Re: Indian Point Unit No. 2
Docket No. 50-247

Subject: Response to the Staff's Requests for Additional Information (RAI) Regarding the Steam Generator Tube Examinations conducted during Spring of 2000 Outage, and the Root Cause Evaluation of the Steam Generator Tube Rupture Event of February 15, 2000 (TAC No. MA8219)

Response to Questions Regarding Steam Generator Tube Examinations
Performed During Spring 2000 Outage

Consolidated Edison Company of New York, Inc.
Indian Point Unit No. 2
Docket No. 50-247
June 2000

Figure 10 Comparison of Tubes Plugged for 0.610" Restrictions

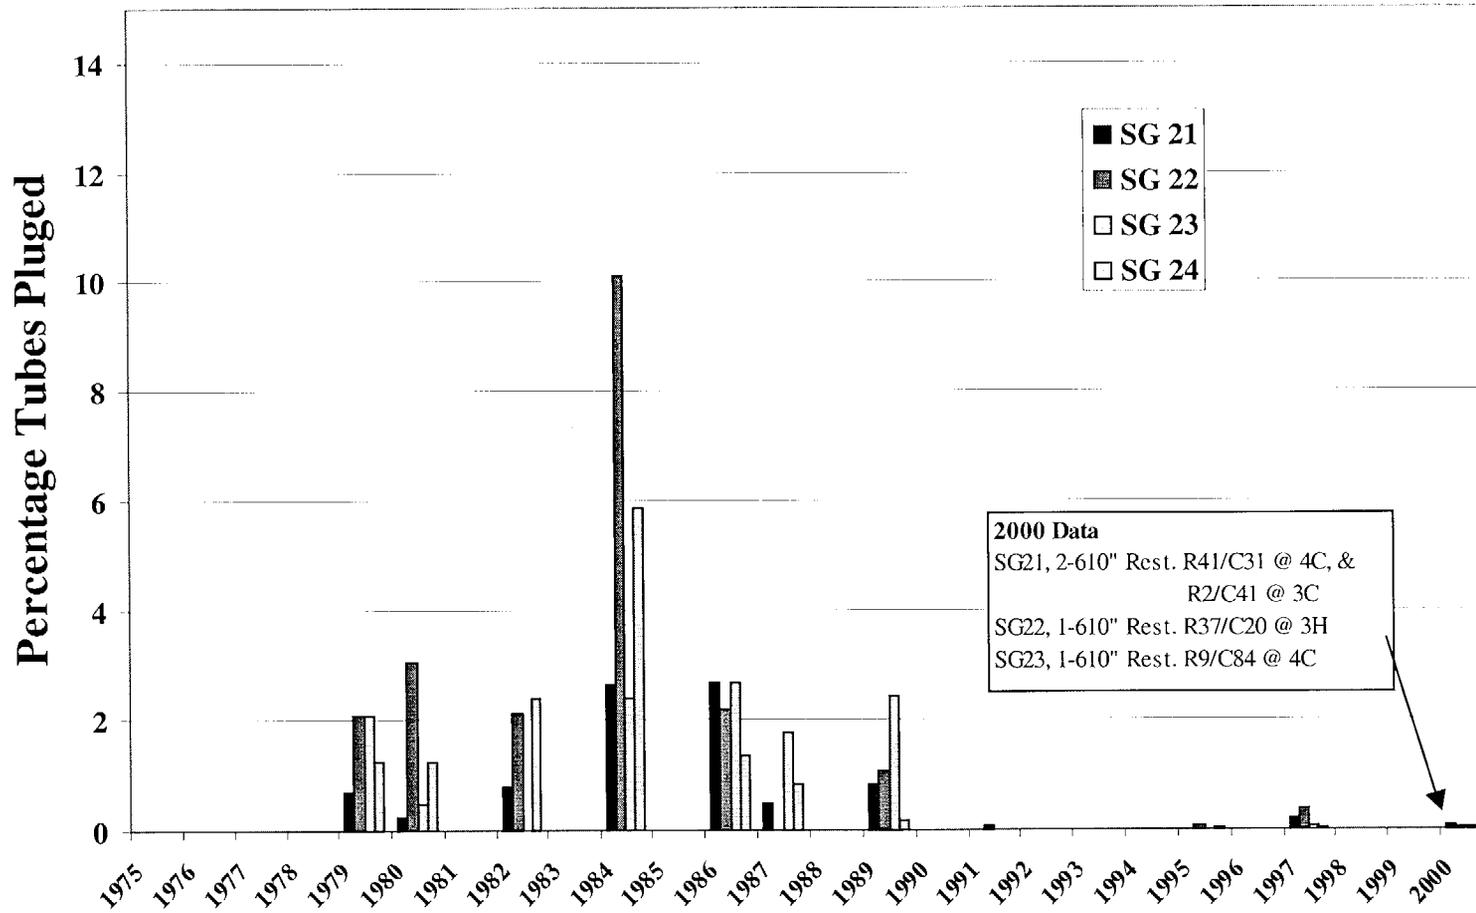
Provide the trending analysis of dents in the upper support plates and ovalization of rows 2, 3, and 4 u-bends. This trending analysis should be displayed in graphical or tabular form as appropriate to best illustrate the trends. A summary discussion should be provided of denting trends in the lower support plates. The licensee's July 29, 1997, inspection reported 20 tubes (mostly in steam generator 22) failed to pass the 0.610 bobbin in rows 2 and 3. Were these tubes able to pass a 0.610 or larger bobbin in earlier inspections? Have the row 2-4 u-bends been inspected with bobbin during the current inspection so as to contribute to the above trending analysis?

Figure 10 shows the number of tubes plugged for 610 mil bobbin probe restrictions as a percentage of the number of tubes inspected each outage since 1975. Tubes that are restricted to the 610 mil bobbin probe were plugged in accordance with the IP2 Technical Specifications.

- The number of tubes plugged as a percentage of those inspected has decreased from 2.5% – 10% in 1984 to <0.1% in 2000 (Figure 10).
- Most of the locations where a direct comparison between 1997 and 2000 could be made showed no change in restriction size (Tables 1-4).
- The rate of flow slot closure has leveled off since 1985.

Figure 1A
Dented Support Lab Sample Used to Support EPRI Appendix H Qual. With .030" Dent, 62% OD Axial Notch
.680" Cecco 5 Probe

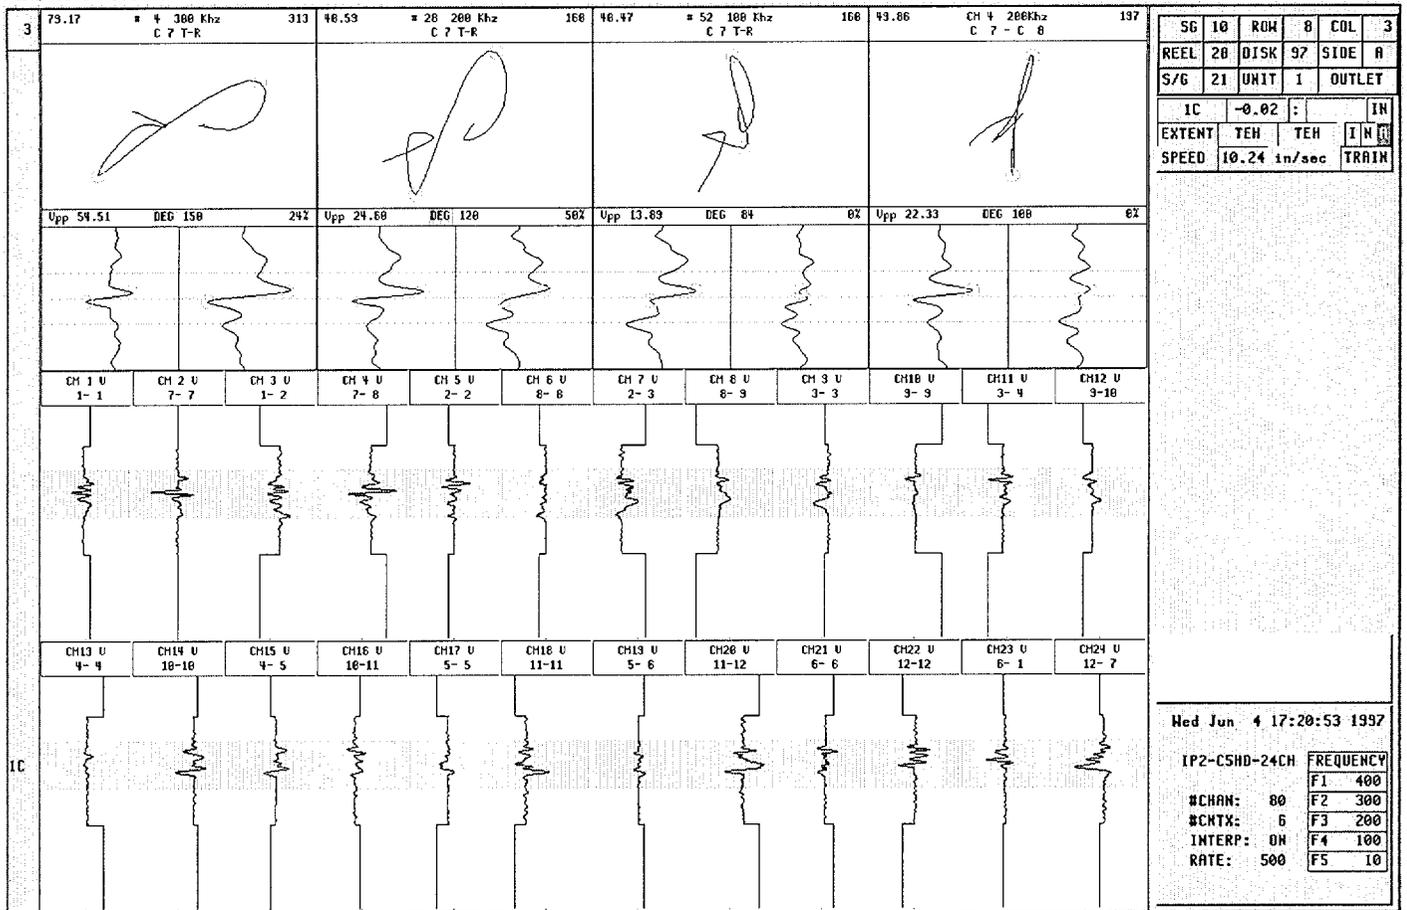
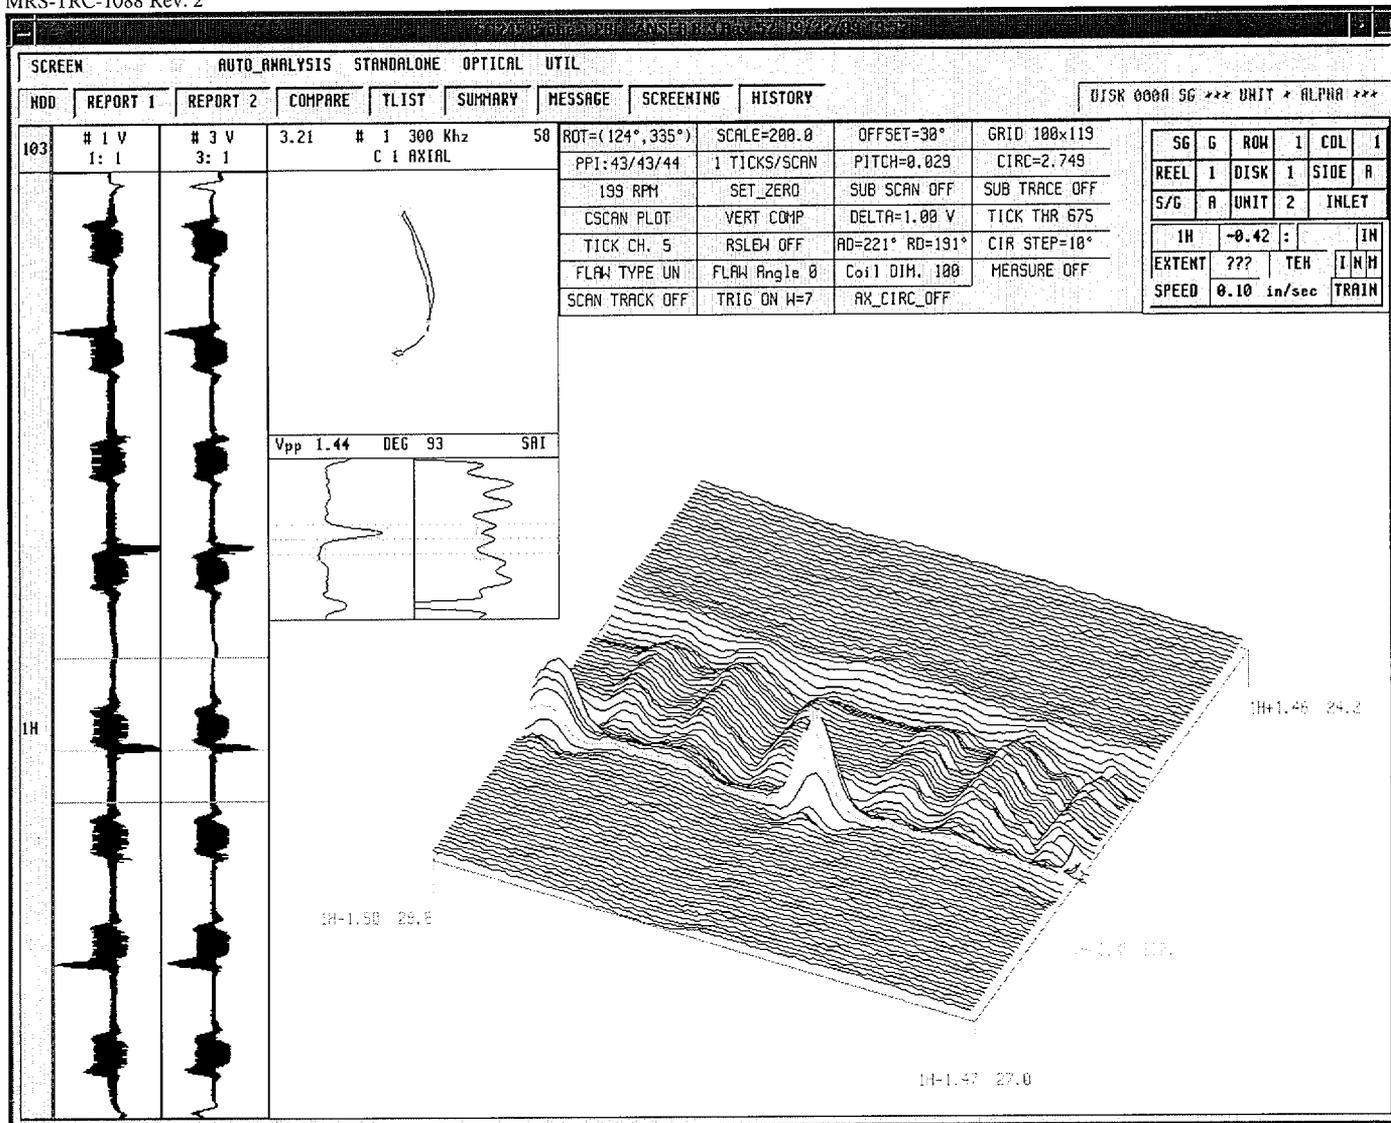
Provide the documentation of the site qualification review of the eddy current techniques applied during the 1997 and 2000 inspections.

1. Axial ODSCC has been reported at Indian Point 2 at dented support plate intersections. **Figure 1A** shows the results from a dented lab sample used to support the EPRI Appendix H qualification for the Cecco-5 probe. **Figure 1B** compares an in-generator signal reported at Indian Point 2 using the Cecco-5 probe. **Figure 2A** shows the results from a lab sample used to support the EPRI Appendix H qualification for the Plus Point coil. **Figure 2B** compares an in-generator signal reported at Indian Point 2 from the Plus Point coil.
